Product: Microwave ovens manufactured by TEKA Portugal

Production dates: *Since W42/2012 – Introduction of Kepar Electronics*

Description: New electronic controllers from electronics supplier KEPAR

Electronic board 4055111787

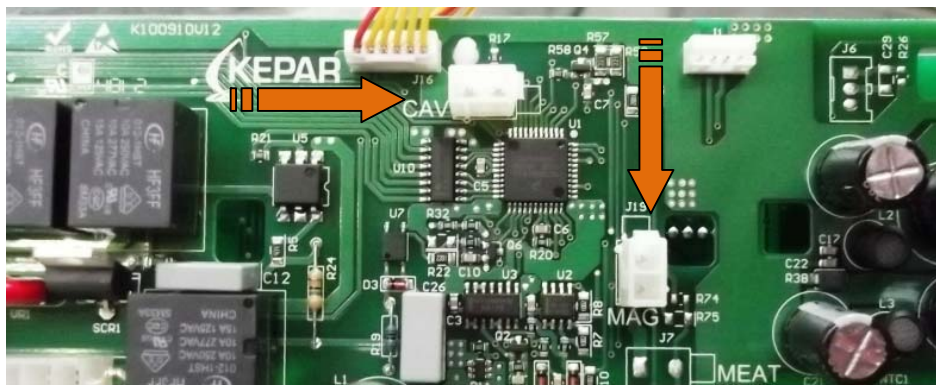
The equivalence between the temperature sensors connectors is the following:

Magnetron temperature sensor → Connector MAG

Cavity temperature sensor → Connector CAV

Magnetron temperature sensor 50299216007 (STM)→Connector MAG

On the field the electronic boards from supplier CWJ can be replaced by Kepar electronics with all compatibility assured.

Interchangeability: *The electronic boards are totally interchangeable.*
